Cotter Corporation
General Office

November 3, 1982

Re: Source Materials License No. SUA-1273 (Docket No. 40-8511)

In response to your July 7, 1982 letter, and consistent with Cotter's scheduling delay requested in its September 3, 1982 letter to you, please find enclosed the information which addresses your concerns about the in-plant safety portion of Cotter's renewal application.

COTTER CORPORATION		
CHARLIE PROJECT ISL		
PRELIMINARY PLANT LAYOUT		
OFFICE and PROCESS EQUIPMENT		
DRAWN BY	SW	REVISION #1
DATE	10-82	#2
SCALE	1"=14 5'	#3

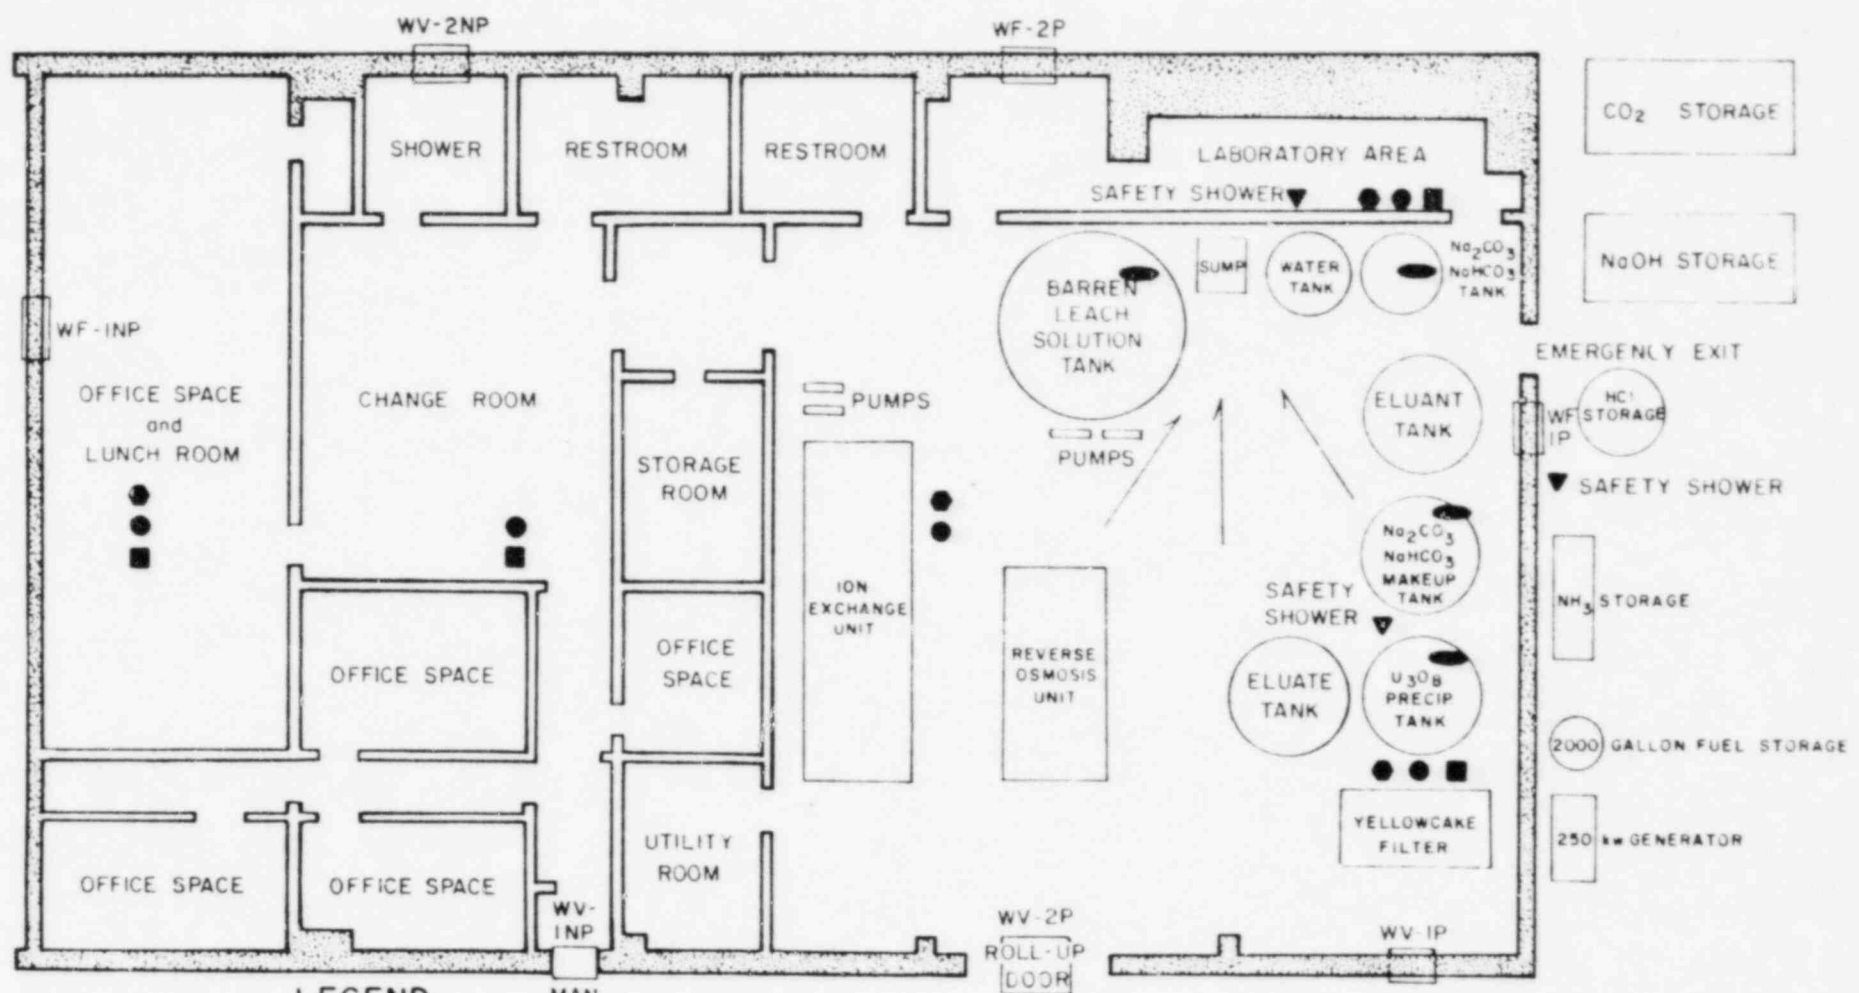
1. P.3-4a provides a description of the proposed fence, and has been enclosed for insertion in the text of the renewal application.
2. P.3-11 has been revised in response to this comment. Although the term "semi-mobile recovery plant" no longer appears on the revised version of P.3-11, its use was intended to convey the temporary nature of the R&D ISL facility.
3. Figure 3-6 has been revised to limit access to, and potential contamination of, non-process areas. A copy of Figure 3-6, as revised, is enclosed herewith.

Please note that gas surge tanks will not be used at this facility, and, accordingly, are not depicted on either Figures 3-5 or 3-6. Solution tanks are depicted on both figures.

6. Section 5.1 at P.8 in the SER has been revised to indicate that the operating procedures consider pertinent radiation safety practices.
7. Section 5.2 at P.9 in the SER has been revised to be consistent with Cotter's Radiation Safety Procedure 1-1, dated May 18, 1982.
8. Section 5.3.2 at P.11 in the SER pertaining to personnel dosimeters has been revised to be consistent with Cotter's Radiation Safety Procedure 4-1, dated May 18, 1982.
9. Section 5.3.4 at P.13 in the SER has been revised to indicate that workers who handle or repair equipment contaminated with yellowcake will wear non-surgical weight rubber gloves.
10. Referring to Figure 3-6, a separate ventilation system for the non-process area and process area will be provided.

Also, referring to Figure 3-6, as originally proposed, all storage and process tanks open to the air within the building will be hooded and vented to the outside atmosphere.

14. Referring to Figure 3-6, as revised, Cotter has planned the construction of a sump in the process area, and has indicated that the concrete floor in the process area will be sloped toward the sump so that all process liquids are contained within the confines of the process area and flow into the sump.

Based on internal volume within the plant of about 179,764 cubic feet and wall ventilation fans with a total capacity of 6,000 cfm, the estimated plant ventilation rate is approximately 2 plant volumes per hour.

For the purpose of alerting plant personnel to the possibility of tankage overflow, all open tanks will be equipped with level alarms and automatic level control systems.
